IN THE DRAWINGS:

REMARKS

Serial No. 10/791,191

Fig. 4D

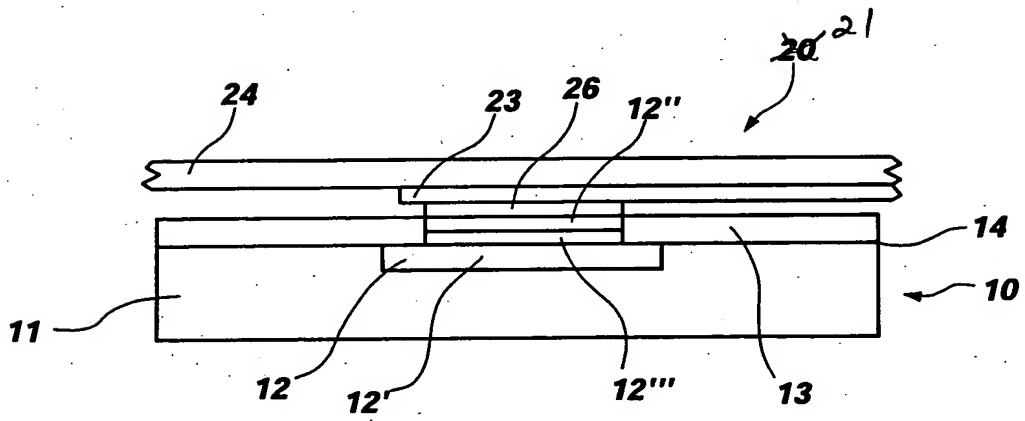
Specifically, FIG. 4D has been revised to change the reference numeral "20" to --21-- to eliminate redundancy with previously used reference numerals; FIG. 5E has been revised to insert --12'-- after "LAYER" on the top line of box 502, to insert --12'-- after "LAYER" in the second line of box 504, to insert --12'-- after "LAYER" and before the comma on the top line of box 508, to insert --12'"-- after "LAYER" and before the comma in the second line of box 508, and to insert --12'-- after "LAYER" in the third line of box 508; FIG. 5F has been revised to insert --23-- after "LEAD" on the top line of box 608 and to insert --21-- after "TAPE" in the second line of box 608; FIG. 5G has been revised to insert --12'-- after "LAYER" on the top line of box 702, to insert --12'-- after "LAYER" on the top line of box 704, to insert --23-- after "LEAD" on the top line of box 708, and to insert --21-- after "TAPE" in the second line of box 708; FIG. 5H has been revised to insert --12'"-- after "LAYER" on the top line of box 806, to insert --12'-- after "LAYER" in the second line of box 806, to insert --23-- after "LEAD" on the top line of box 812, and to insert --21-- after "TAPE" in the second line of box 812; FIG. 5I has been revised to insert --23-- after "LEAD" on the top line of box 910 and to insert --21-- after "TAPE" in the second line of box 910; and FIG. 5J has been revised to insert --12'-- after "LAYER" in the second line of box 1004, to insert --12'-- after "LAYER" and before the comma on the top line of box 1008, to insert --12'"-- after "LAYER" and before the comma in the second line of box 1008, to insert --12'"-- after "LAYER" in the third line of box 1008, to insert --23-- after "LEAD" on the top line of box 1010, and to insert --21-- after "TAPE" in the second line of box 1010. No new matter has been added.
